# UNITED STATES PATENT AND TRADEMARK OFFICE

## Office Action Summary

This is the first office action for application number 10/757,535, T-Connector Holding Tool and Method, filed on January 15, 2004.

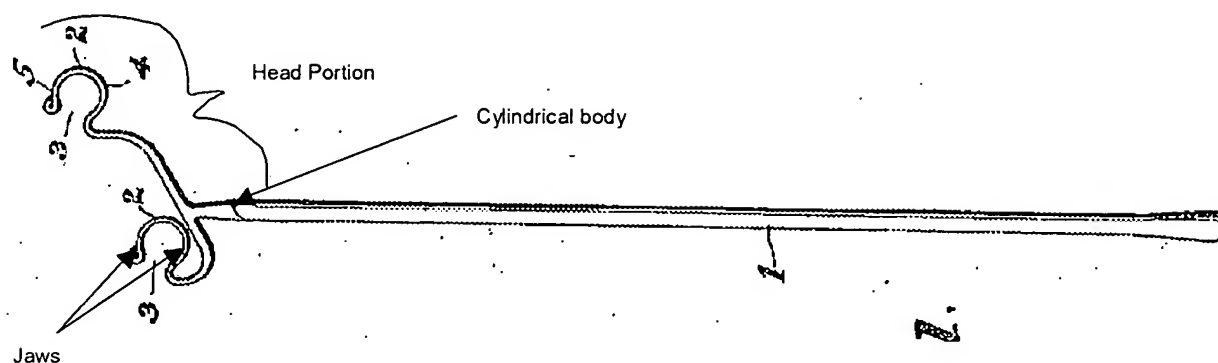
Claims 1 and 2 are rejected under 35 U.S.C. 102(b) as being anticipated by U.S. Patent number 1,006,721 to Clark.

Clark '721 discloses a tool (above) comprising an elongated handle portion with a grip portion (1) and a head portion (above) fixed to the handle portion having capturing means, wherein the head portion has a cylindrical body (above), wherein the capturing means comprises a pair of spaced rigid claws (2, inherently rigid relative to at least something else), each claw including an smooth arcuate interior cylindrical surface (above) that extends a majority around a circumference of a cylinder that is inherently adapted to capture an aligned nut so as to prevent lateral movement of two aligned nuts, wherein an axis of the cylinder is generally perpendicular to an axis of the handle portion, wherein each claw comprises a pair of jaws (above) inherently adapted for extending around a respective side of one of the aligned nuts so as to prevent lateral movement of the nut.
